ADDENDUM NO. 01 (Date: June 27, 2022)

Fairhope Sewer Upgrade Phase I

Bid No. 005-22 – Lift Station Rehabilitation

Project: Lift Station Rehabilitation, ADCNR Grant #S1P25-FSU1

6A

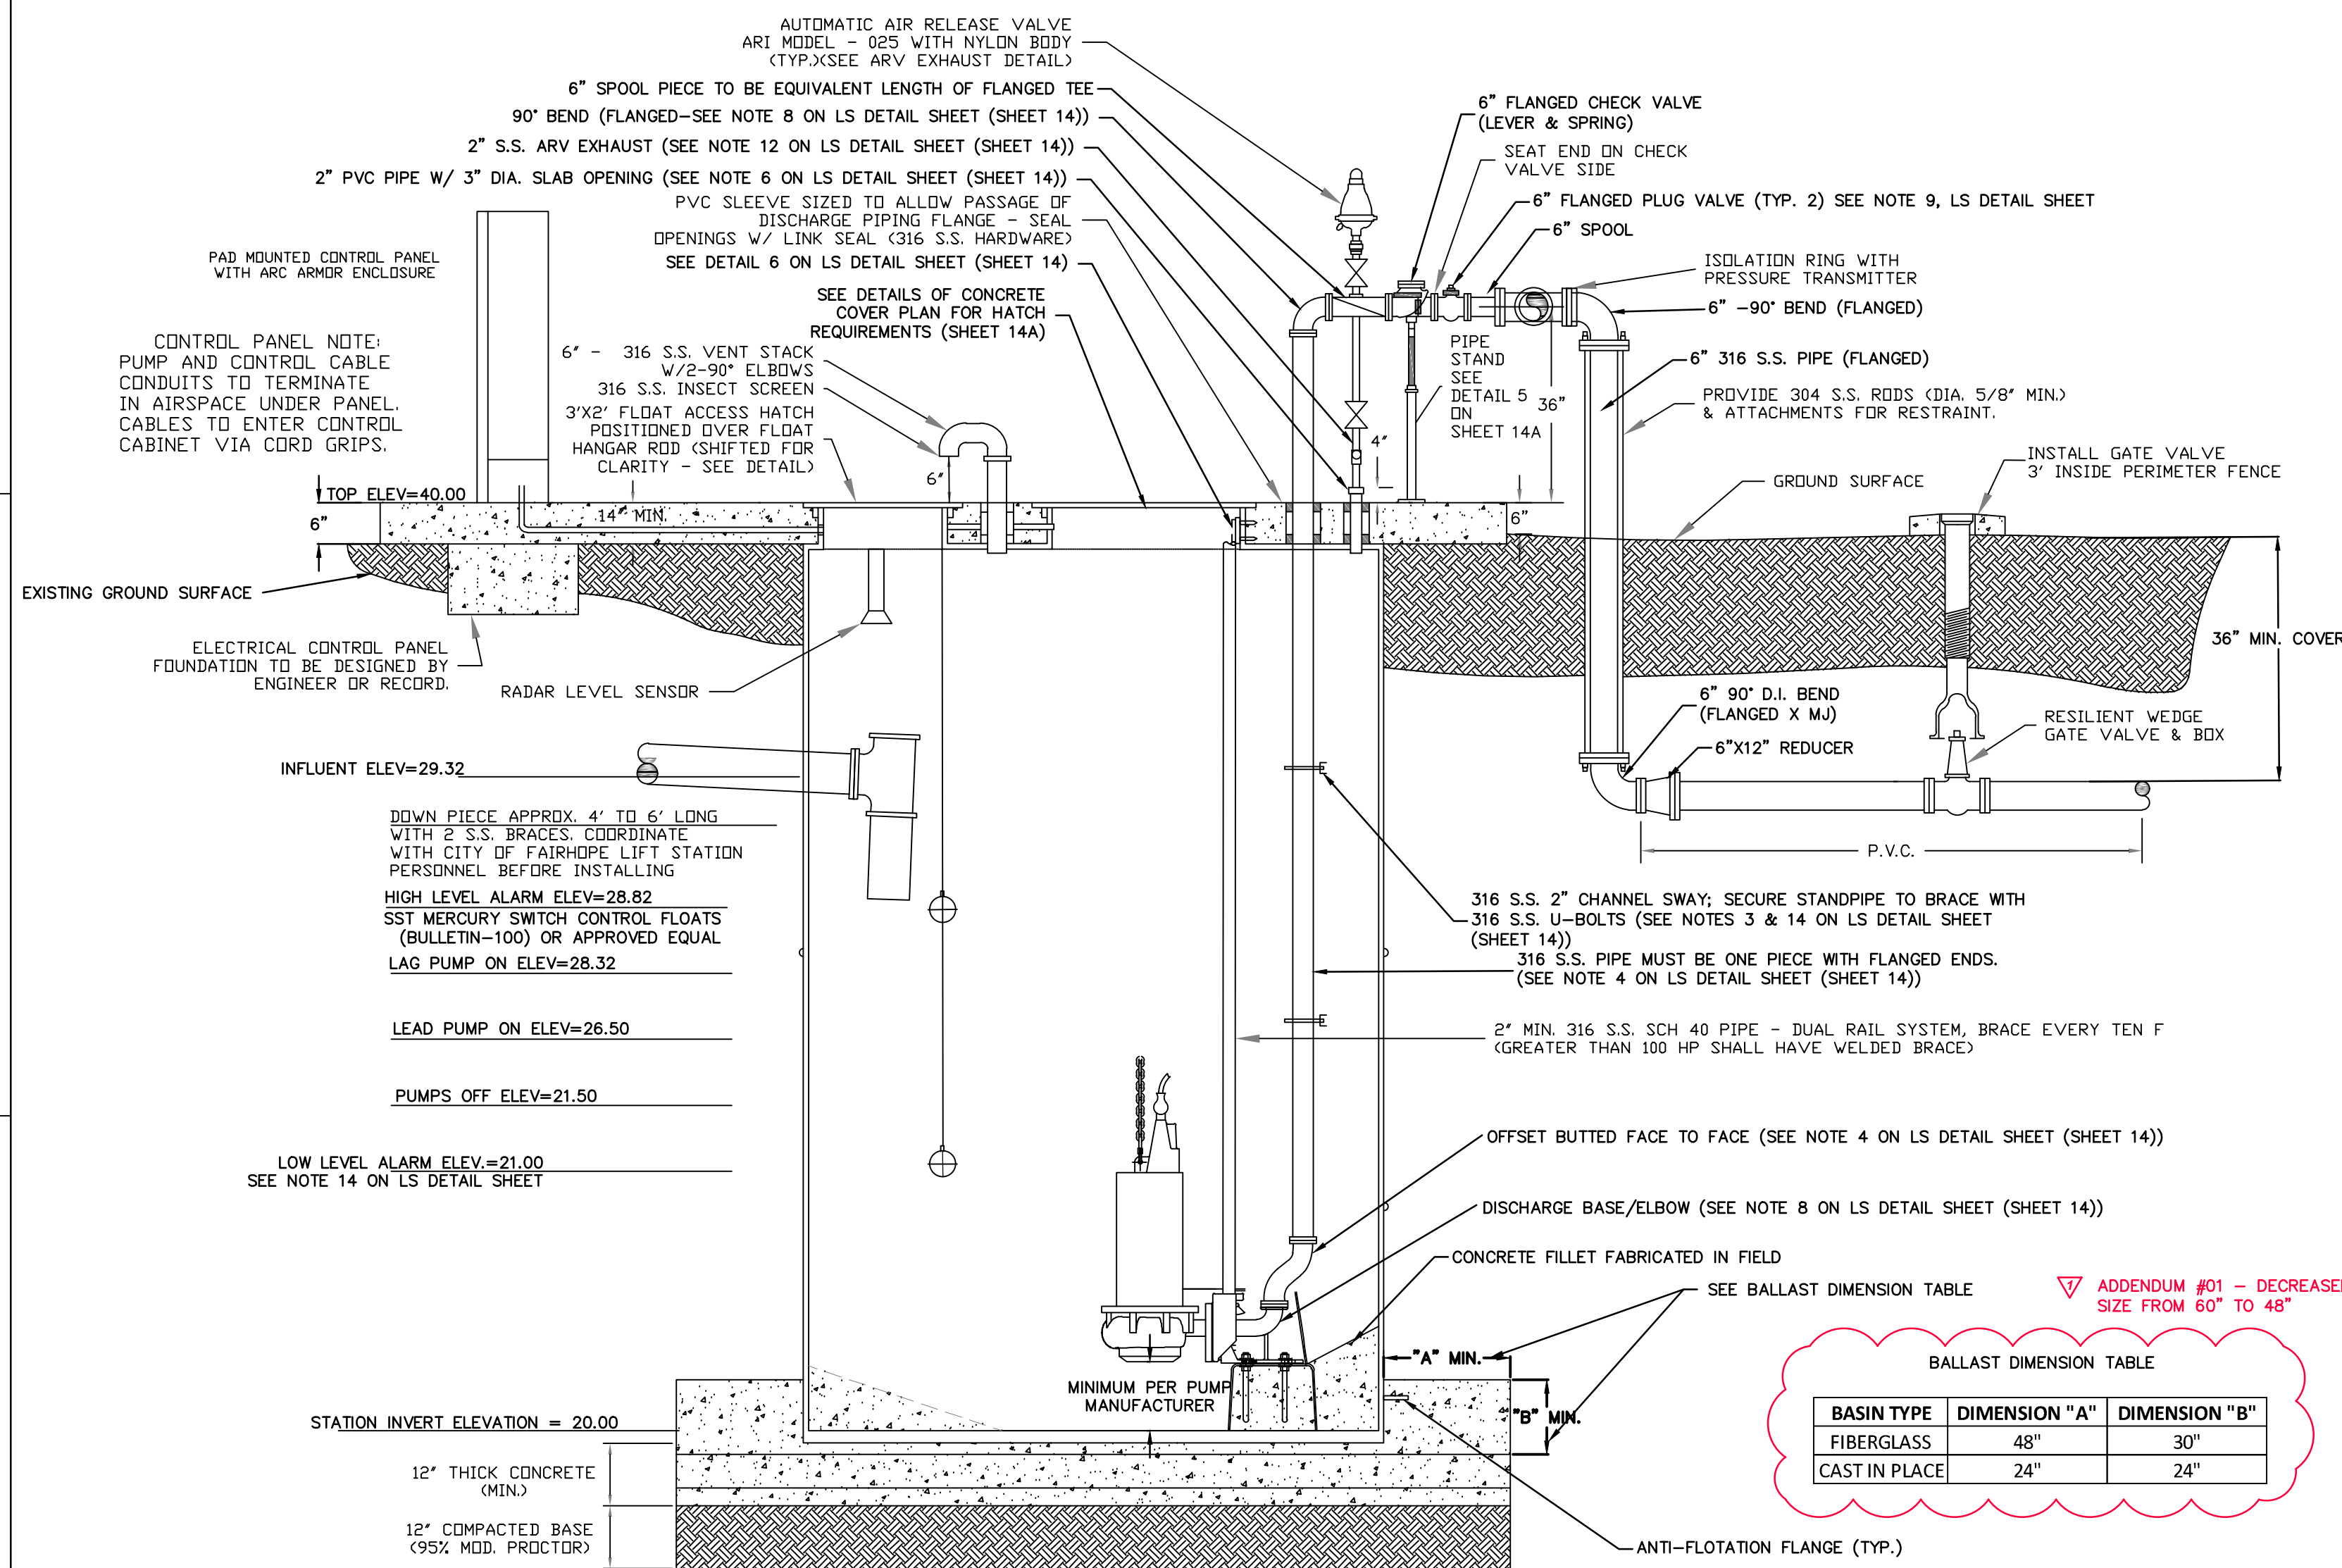
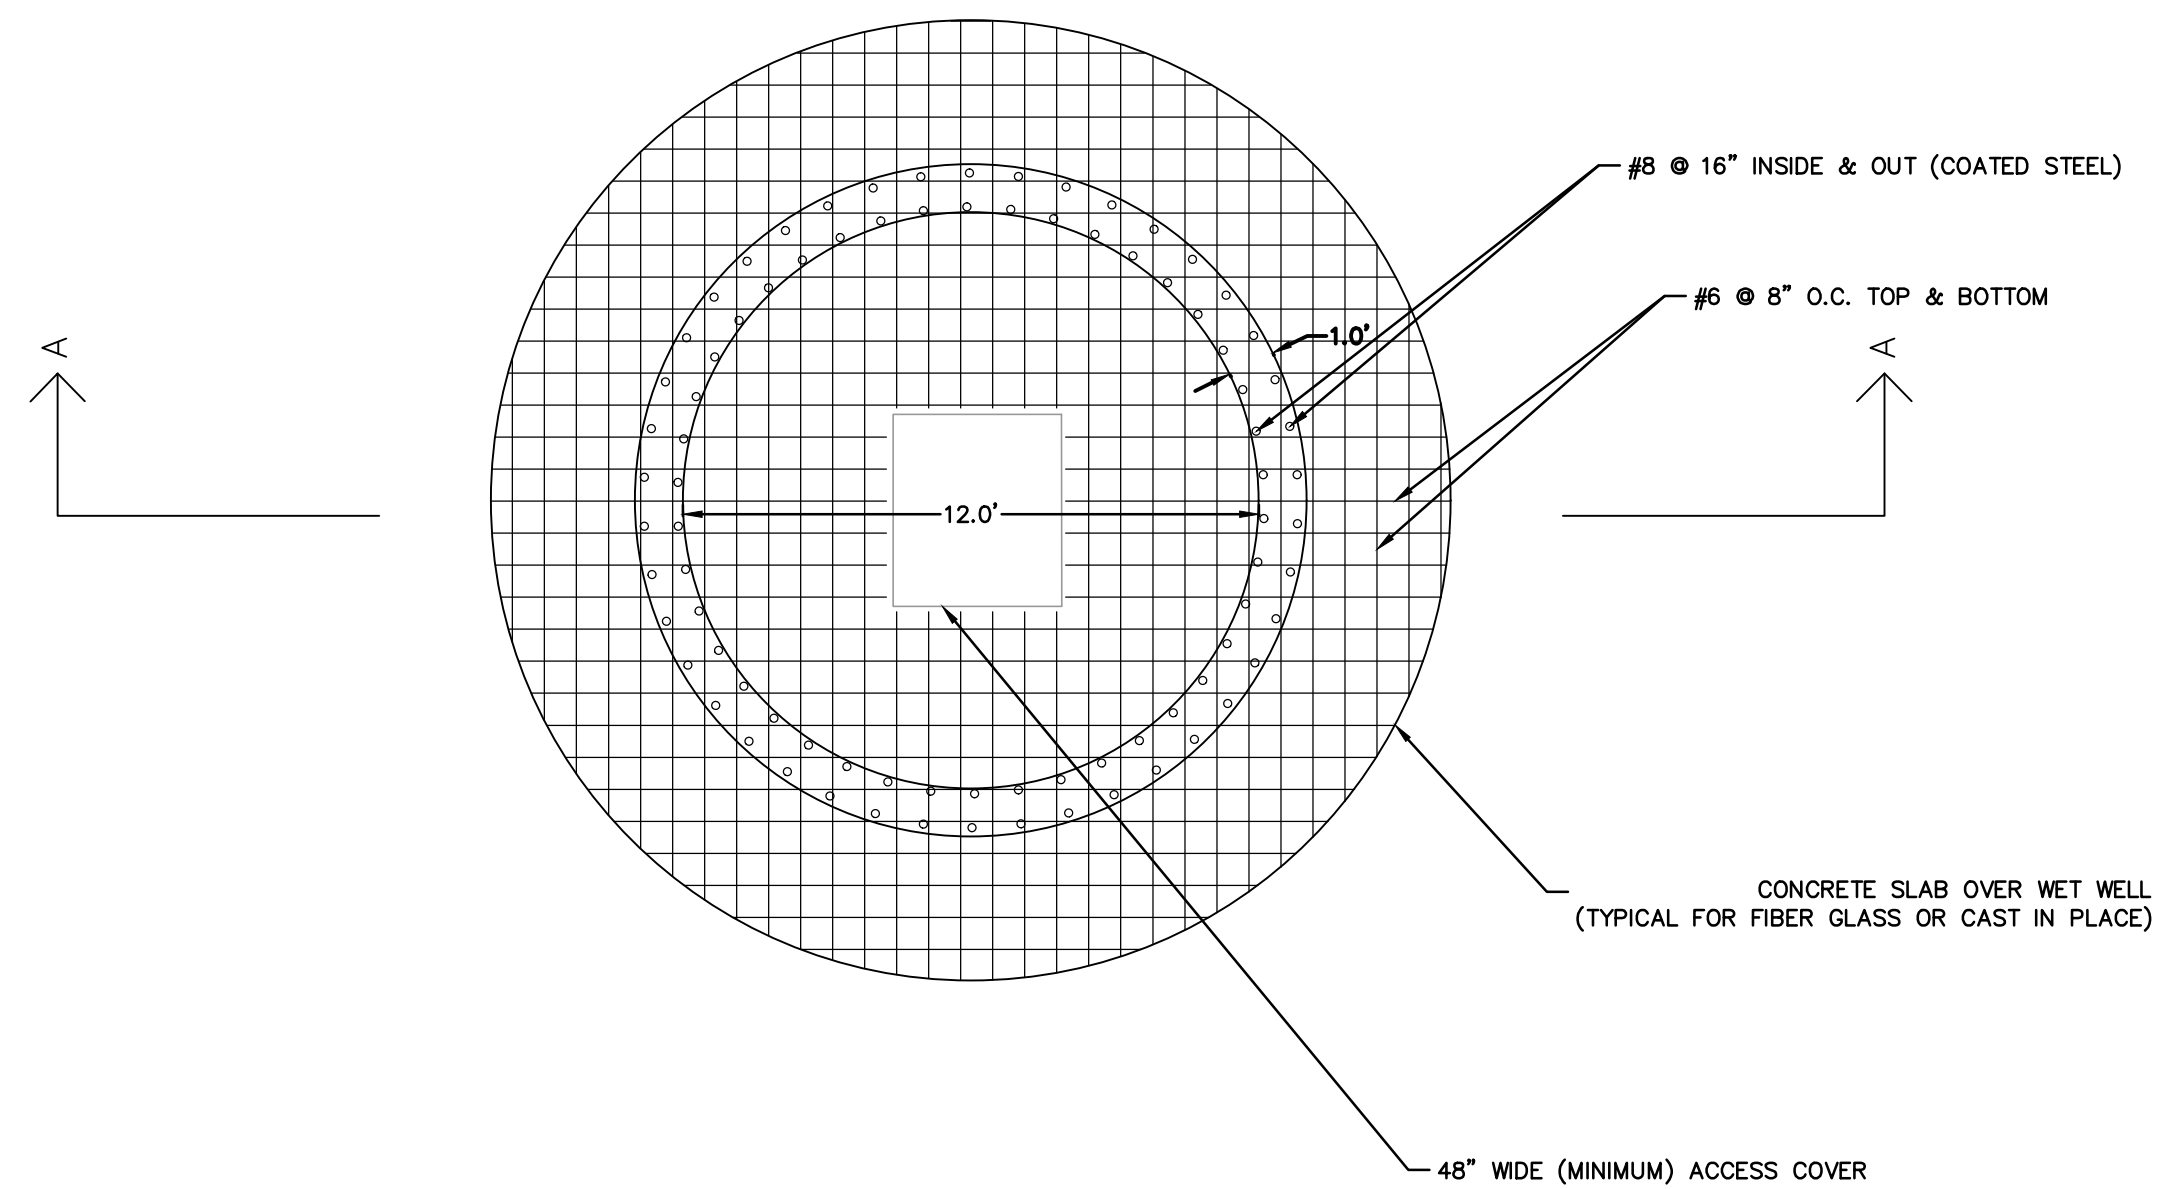
ADDENDUM #01 - DECREASED DIMENSION "A" FIBERGLASS BALLAST SIZE FROM 60" TO 48"

BALLAST DIMENSION TABLE		
BASIN TYPE	DIMENSION "A"	DIMENSION "B"
FIBERGLASS	48"	30"
CAST IN PLACE	24"	24"
